Technical Bulletin

Model: AG-P1	Date: 18-Sep-08	No.: RG178001c

a italioo haro boon addo			
Subject: Firmwar	re Release Note: NIB		Prepared	d by: H.Matsui
From: PPBG/Ser	vice Planning Dept.			
Classification:	☐ Troubleshooting ☐ Mechanical	☐ Part informa☐ Electrical	tion	☐ Action required ☐ Service manual revision
	☐ Paper path ☐ Other ()	☐ Transmit/rec	eive	☐ Retrofit information

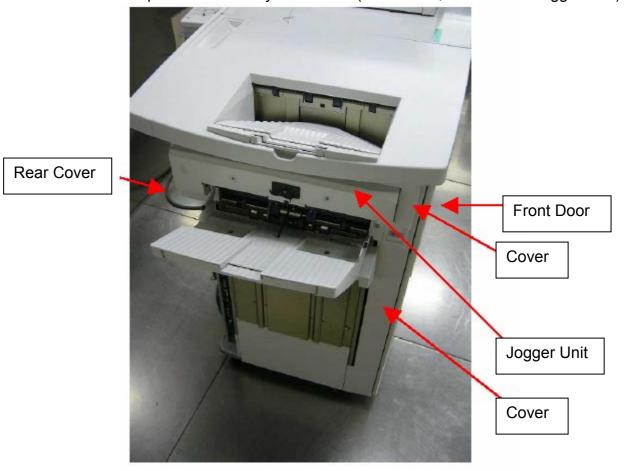
An altered exit drive roller without the brim (**B8309533**) is available as an individual corresponding part.

Stacking failure and paper ejection failure may occur when thin paper is used for this roller. These symptoms are presently seen when Classic White (A3 size) is used. Be sure to give due consideration to this side effect when supporting the users.

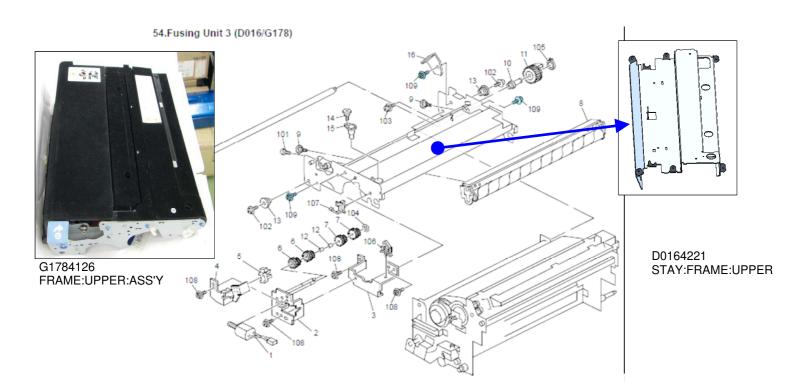
The above two parts have been newly added as spare parts.

Please apply these parts when modifying the current fusing unit (with 1 hole for oil supply) to the NEW fusing unit (with 2 holes.)

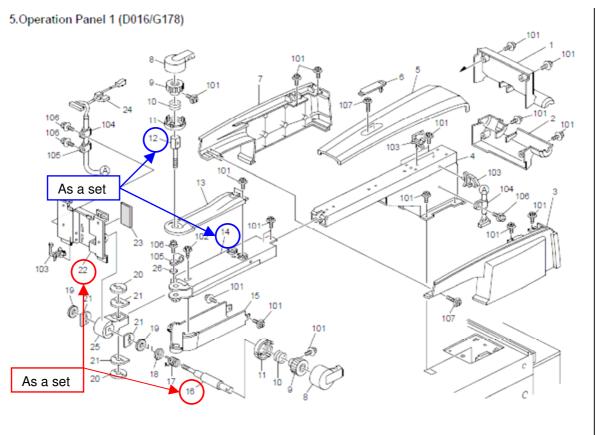
The 4 relative parts have been modified to gain higher tolerance.

If a machine requires replacement of these parts, please replace them as a set as described in the table above and diagram below.

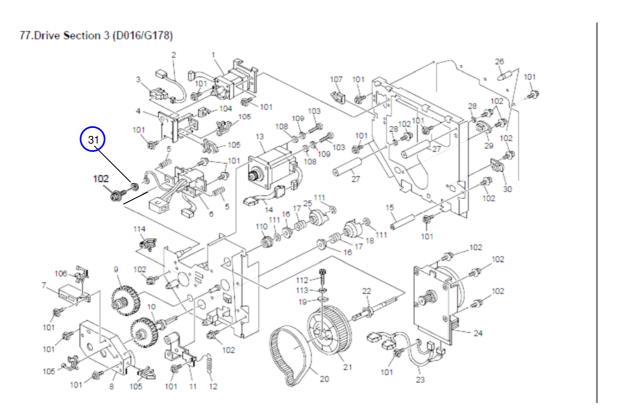
Reason: A screw hole in the drive section was damaged in the manufacturing process. 'Washer: M4' has been added to prevent this problem. Damage to this screw

hole has not been reported from the field.

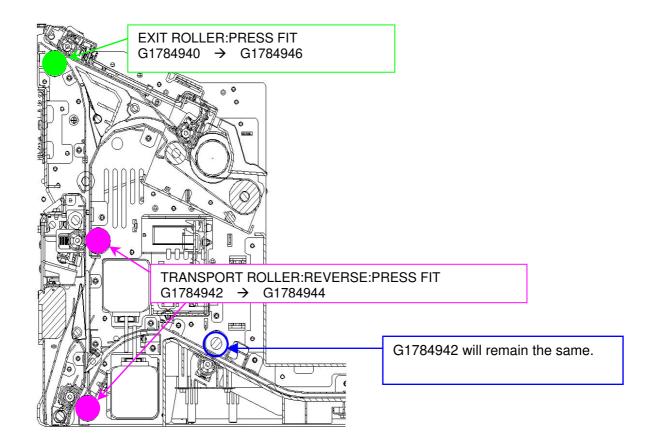
Material of the EXIT ROLLER and TRANSPORT ROLLER has been changed from EPDM rubber to urethane for better grip. When a replacement is required for any of the following 3 rollers, replace them as a set.

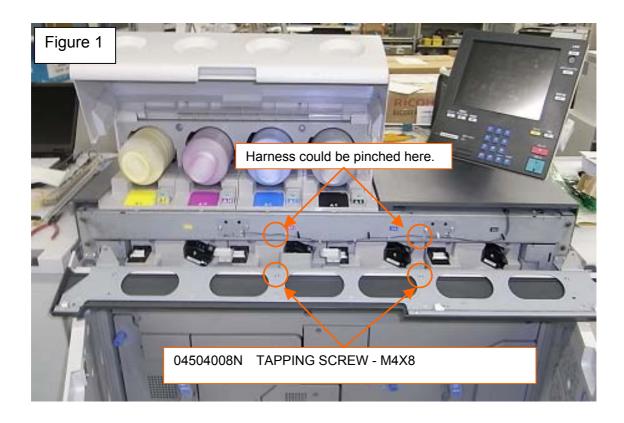
Screws applied to the front-top cover have been changed to prevent damage to the harness when attaching the cover (See figure 1).

The new screws will allow securing a 0.6mm gap between the frame and the screw head (See figure 2).

Please refer to figures 3-1 and 3-2 for details.

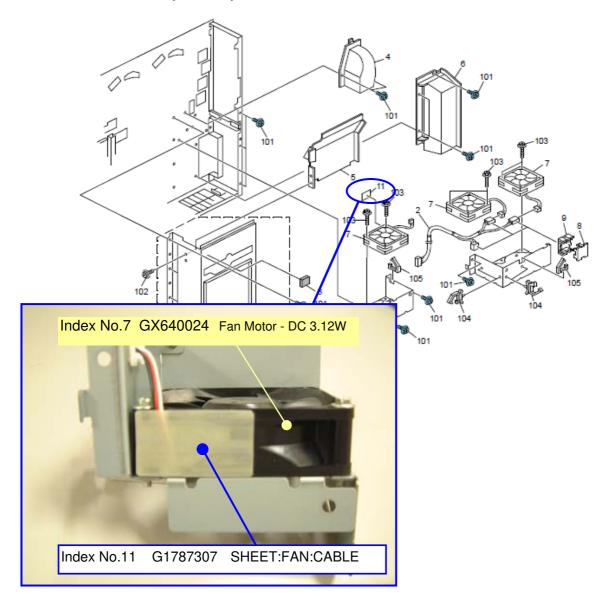
Improvement in the factory assembling process: a protection sheet has been added to the fan component to prevent damage to the harness.

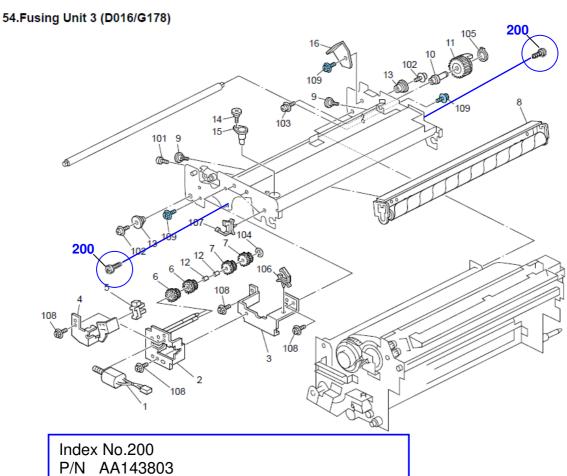
*2) The screws indexed 200 have been added to the locations shown in the diagram below in the modified fusing unit.
